PROJECT THE WORLD TRADE CENTER

TITLE ZONE K-3 EL 332 REPAIR DET. AT TOP FLANGE CONN. ℄ BETWEEN 65×24 GIRDER AND 65/68×24 GIRDER AT COLUMN H5-9

DATE 2-28-74

19-K-1091

Plan View

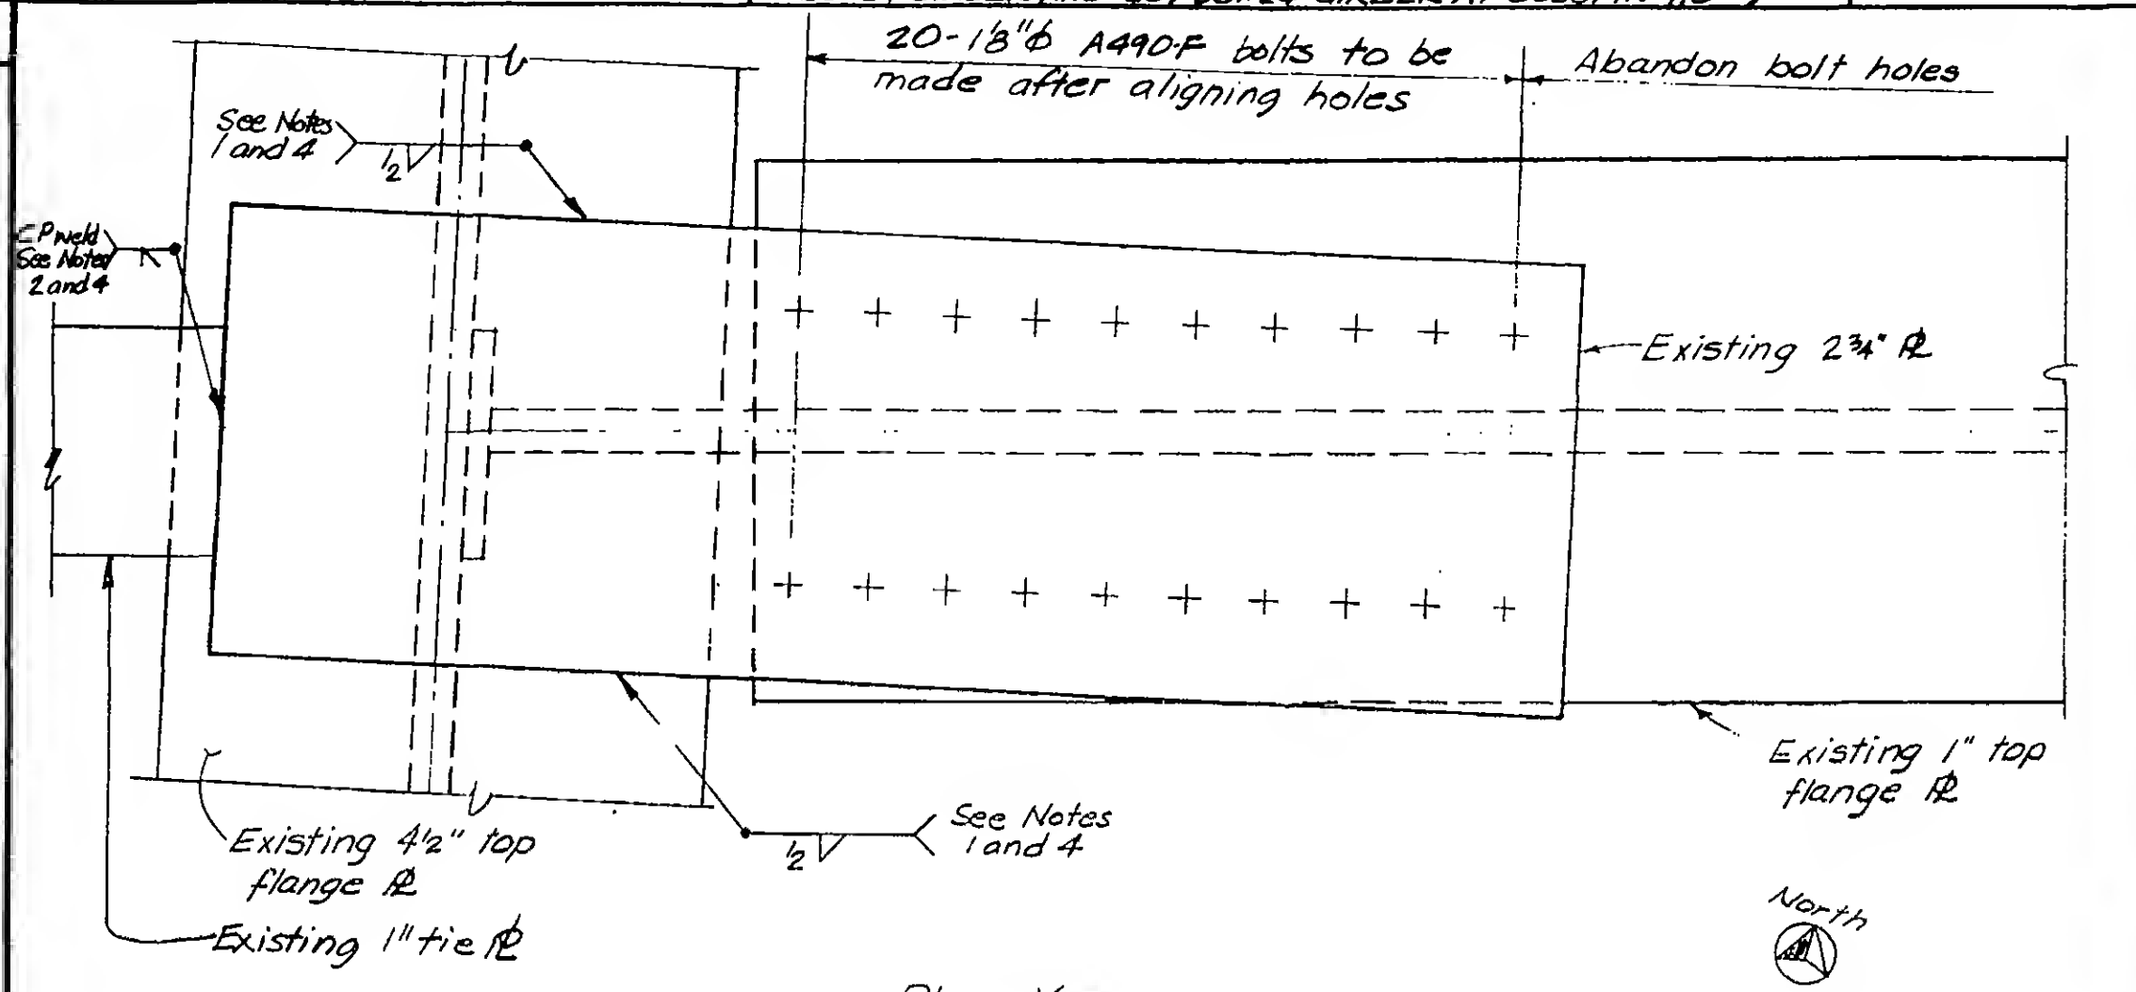
1. Remove ½" fillet weld on each side of 2¾" ℄.
2. Remove CP weld connecting 2¾" ℄ to 1" ℄.
3. Position 2¾" ℄ to make all 20-1⅛" ϕ bolts. Do not remove the four 1⅛" ϕ bolts made through 1" ℄.

IMPORTANT: After repositioning 2¾" ℄, be sure that it seats against the finished portion of Girder G561 since a future column will be placed on it. After repositioning of 2¾" ℄, if complete seating (contact) is not obtained, notify ENGINEER
4. Replace the ½" fillet welds on both sides of 2¾" ℄ and the CP weld connecting 2¾" ℄ to 1" ℄.
